Deadline 5 Submission

Dr Anne Noble

This response covers points raised in REP5 -056, 058 and 065 in order to avoid repetitions.

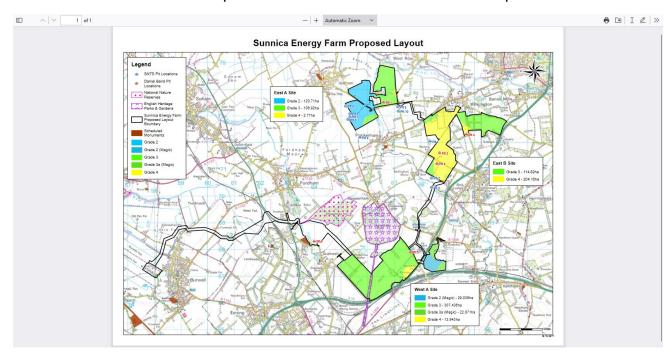
It is clear that DBSC has assumed the presence of *some* soil material beneath what has been stated in the profile logs, but there is no explanation of what assumptions have been made in order to arrive at the conclusion. For example, the first profile investigated by RAC is LF4. The DBSC profile notes 30cm medium sandy loam topsoil with 10% hard stone, overlying another 20cm of medium sandy loam with 10% hard stone. The moisture balances are noted as -28mm for wheat and -24mm for potato.

If the profile is assessed as stated with no additional material below 50cm depth, the moisture balances are -48mm for wheat and -45mm for potato (too droughty). If the profile is assessed as stated, with the addition of a logical assumption of the subsoil becoming more stony and passing to sand and gravel at depth, the moisture balances are -18mm for wheat and -23mm for potato (not droughty enough). The DBSC moisture balances have assumed something between these two scenarios with no associated justification. RAC has managed to achieve the same moisture balances as DBSC in profile LF4, by assuming a lower subsoil of medium sandy loam with

35% hard stone overlying rock at the arbitrary depth of 77cm. There is no logical reason why 77cm would be selected.
